V2500-D5 SERIES PROPULSION SYSTEM SERVICE BULLETIN

This document transmits Revision 1 to Service Bulletin EV2500-77-0010 and
 Revision 1 to the Supplement

ENGINE INDICATING – EGT HARNESS AND JUNCTION BOX – INTRODUCTION OF A EGT HARNESS
JUNCTION BOX ASSEMBLY WITH REVISED SELF LOCKING NUTS

SB1-77-28-01-BASIC

TYPICAL THERMOCOUPLE CABLE TEST DIAGRAM
FIGURE 101

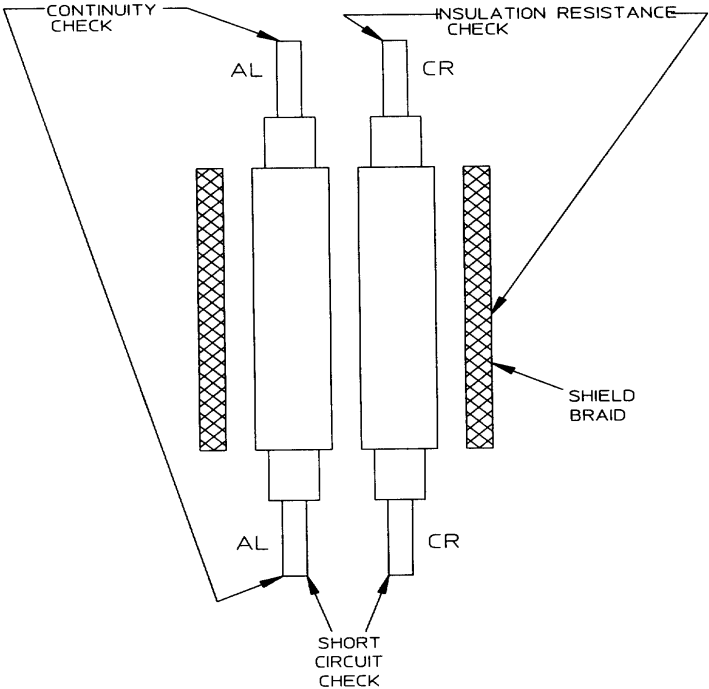
To do a continuity and intermittent (broken wire) test; set the range switch of the multimeter to approximately ten ohms or less.

- (a) Use the schematic wiring diagram (Figure 102) to do this continuity test.
- (b) Measure the resistance values of each wire from its thermocouple terminal lug to its output terminal stud as follows:

Connect the wire from the multimeter to the input lug of a harness wire, then connect the other wire from the multimeter to the output stud (in the junction box) of the same harness wire.

The resistance value in each case must be less than two (2) Ohms. If the resistance value is high or changes when you bend the wire, the harness assembly is not satisfactory.

SCHEMATIC WIRING DIAGRAM
PART NO. HAD20759
FIGURE 102

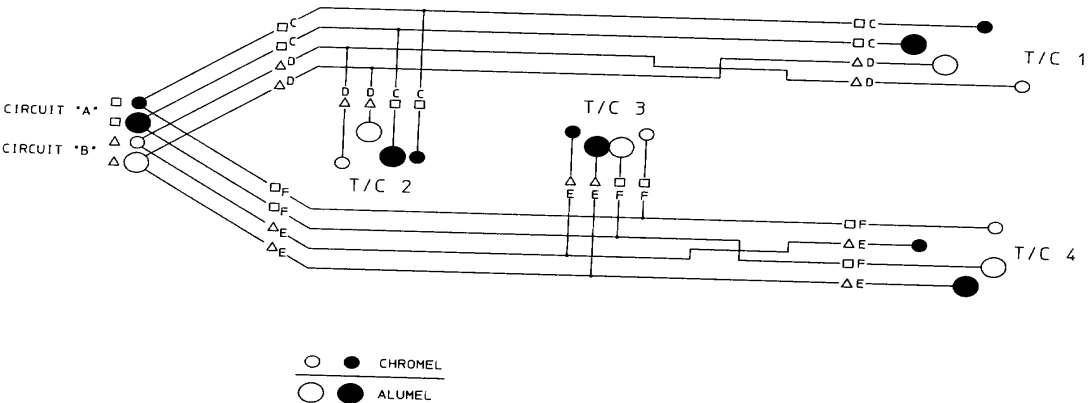
(2) **Short Circuit Test** (Figure 102)

- (a) Set the megohmmeter to zero and make sure that it operates correctly. Set the scale to get values up to 10 megohms at 100 "VDC".
- (b) Do a test for short circuits between all parts of the "A" and the "B" circuits. Use the test wires from the megohmmeter to connect the terminal studs in the junction box as follows:

- (1) Connect wire one from the megohmmeter to the chromel stud of the "A" circuit.
 - (2) Connect wire two from the megohmmeter to the alumel stud of the "A" circuit and measure the resistance value.

If resistance is below 1 megohm at 100 vdc, the assembly is not satisfactory.
